Application for a Certificate of Public Convenience and Necessity (CPCN) for the Okanagan Capacity Upgrade (OCU) Project (Application) ~ Project No. 1599152

Response to the Residential Consumer Intervener Association (RCIA) Information Request (IR) No. 1 on Supplementary Filing

FortisBC Energy Inc. (FEI or the Company) Application for a CPCN for the Okanagan Capacity Upgrade (OCU) Project (Application)	Submission Date: July 14, 2023
Response to the Residential Consumer Intervener Association (RCIA) Information Request (IR) No. 1 on Supplementary Filing	Page 1

Figure 2-1: Supplementary Filing Peak Demand Forecast

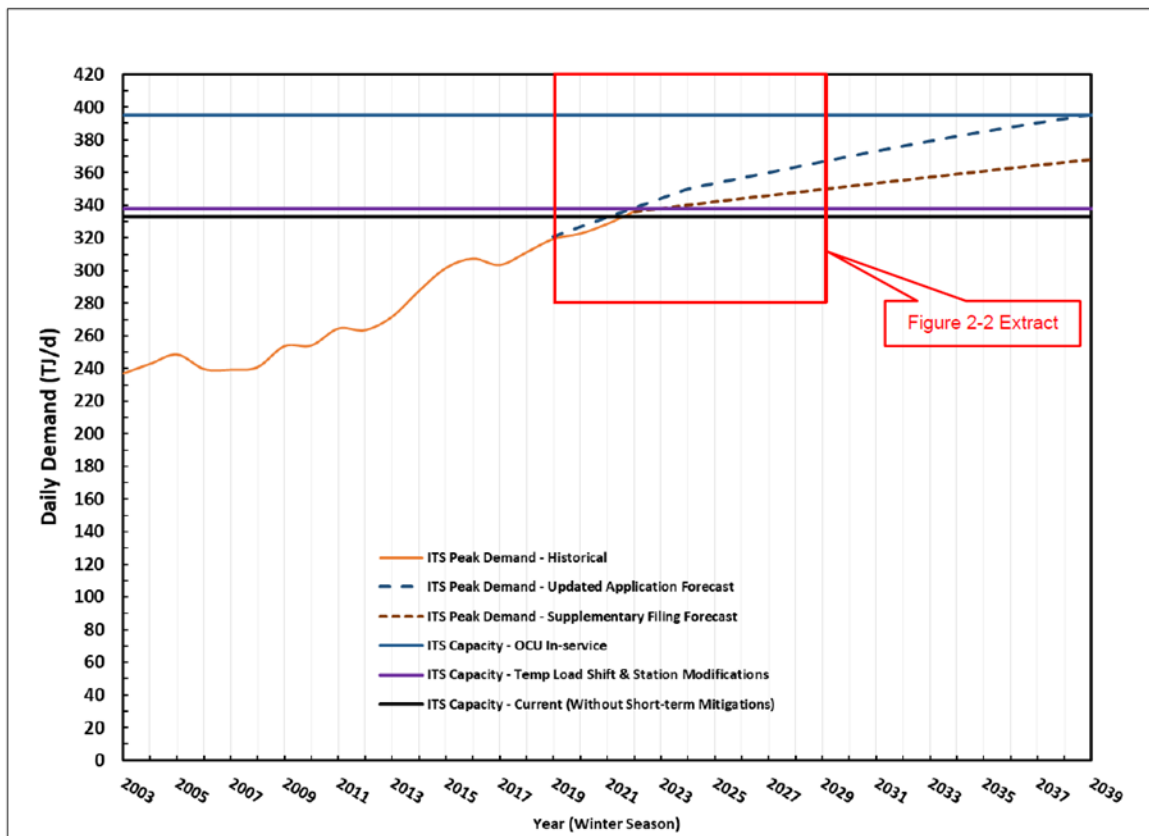
7 On page 4 of its Supplementary Filing, FEI shows that the revised forecast ITS demand
 8 does not reach the ITS capacity with the OCU in service over the study period:

2
3 50.1 Please confirm whether FEI considered re-scoping the preferred Alternative 3 to
4 take into account the reduced demand growth. Changes to Alternative 3 could
5 include a smaller diameter pipeline or a shorter length (i.e., relocate the proposed
6 Chute Lake PRS to a point closer to Penticton, such as 6 km south where the right-
7 of-way crosses Chute Lake Road, or further south to avoid crossing Naramata
8 Creek). Any changes should still result in the OCU project meeting the revised
9 projected demand through the study period.

10 50.1.1 Please provide a graph showing the ITS peak demand based on the
11 supplementary forecast, the existing ITS capacity, the ITS capacity with
12 the Alternative 3 OLI PEN 406 extension, and the ITS capacity with a
13 modified Alternative 3 that shortens the OLI PEN 406 extension.

14 50.1.2 Please explain why FEI is not pursuing such options, or if FEI did
15 consider them, why these options are inferior to the proposed option.

16 50.1.3 Please estimate the change in cost of such of options compared to the
17 original cost considered in the evaluation (that is, estimate how the
18 original cost estimates would change, not how the costs updated in the
19 Supplementary Filing would change).

23
24
25
26 50.2 Please confirm whether FEI considered re-scoping Alternative 1 to take into
27 account the reduced demand growth. Changes to Alternative 1 could include
28 replacing only those segments closer to Penticton and installing a new control
29 station between Penticton and Kelowna (so as to increase the MOP of VER PEN
30 323 up to the new control station) or eliminating the upgrade to the Coldstream
31 lateral. Any changes should still result in the OCU project meeting the revised
32 projected demand through the study period.

33 50.2.1 Please provide a graph showing the ITS peak demand based on the
34 supplementary forecast, the existing ITS capacity, the ITS capacity with
35 the Alternative 1 modifications, and the ITS capacity with a modified
36 Alternative 1 that increases the MOP of VER PEN 323 for only a portion
37 of the originally proposed 35.5 km length.

22 Please refer to the responses to the BCUC Supplementary IR1 13 series.

7 FEI reviewed Alternative 1 in consideration of the Supplementary Filing Forecast and found that
8 there was no opportunity to reduce the scope.

9 With the elimination of the Coldstream lateral upgrade and the remainder of the scope of
10 Alternative 1 staying as defined in Section 4.3.1 of the Updated Application, the alternative would
11 only provide sufficient capacity for the region until 2040, which no longer meets the 20-year
12 planning criteria. Therefore, there was no opportunity to re-scope when considering the reduced
13 demand forecast in the Supplementary Filing. As a result, FEI has not prepared and is unable to
14 provide the requested cost estimate and graph of the ITS capacity for a re-scoped Alternative 1.

15 Please refer to the responses to BCUC Supplementary IR1 11.1 and 16.17 for a description of
16 FEI's review and consideration of the alternatives evaluation. Based on this review, and in
17 consideration of the Supplementary Filing Forecast, FEI determined that the originally selected
18 alternative, an extension of the existing OLI PEN 406 pipeline, remains the preferred alternative.

Figure 2-2: Extract from Supplementary Filing Peak Demand Forecast

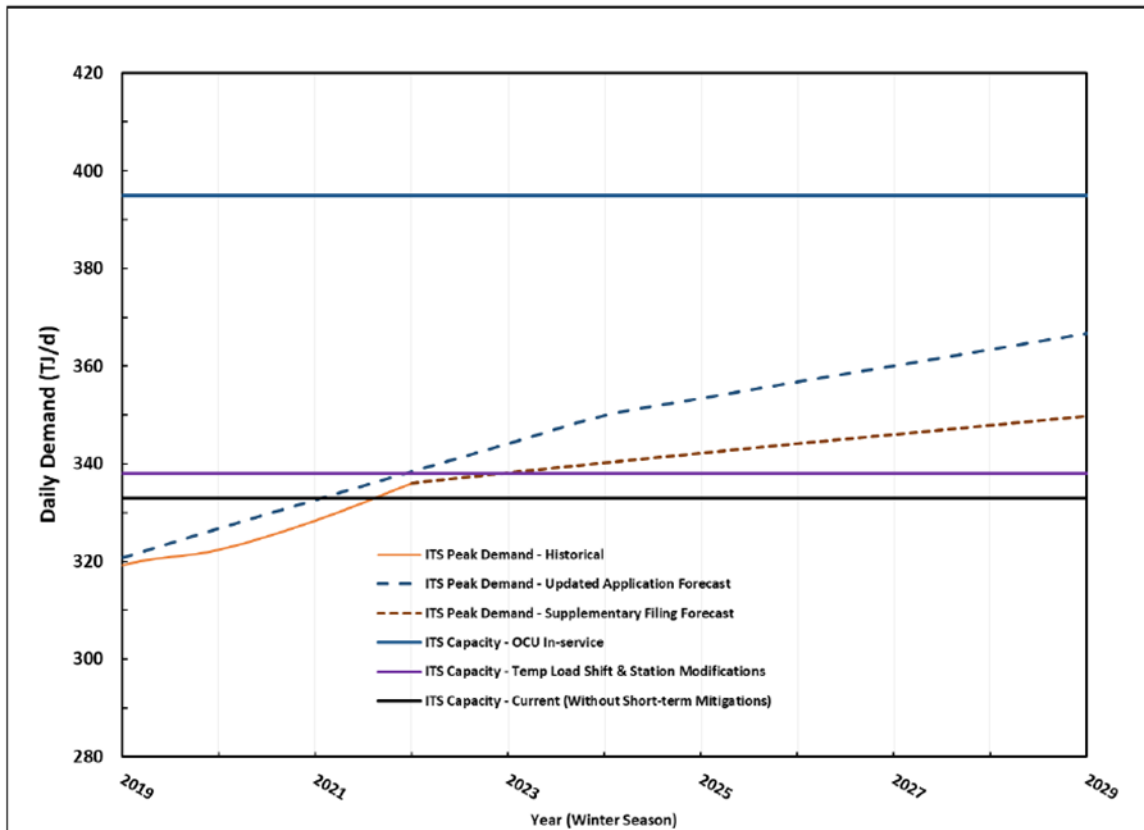
7 On page 5 of its Supplementary Filing, FEI shows that the revised forecast ITS demand:

9 51.1 Please provide the main reasons for the reduction in historical peak demand
 10 compared to the peak demand previously forecasted in the OCU Updated
 11 Application for the years 2019 to 2022. Please address specific factors such as
 12 customer numbers and average consumption on a class by class basis.

1
2 51.2 Please explain the main reasons why the demand is expected to increase at a
3 lower rate than previously forecasted in the OCU Updated Application.

15 Please refer to the response to BCUC Supplementary IR1 1.4.

6 Please refer to the response to BCUC Supplementary IR1 1.3.
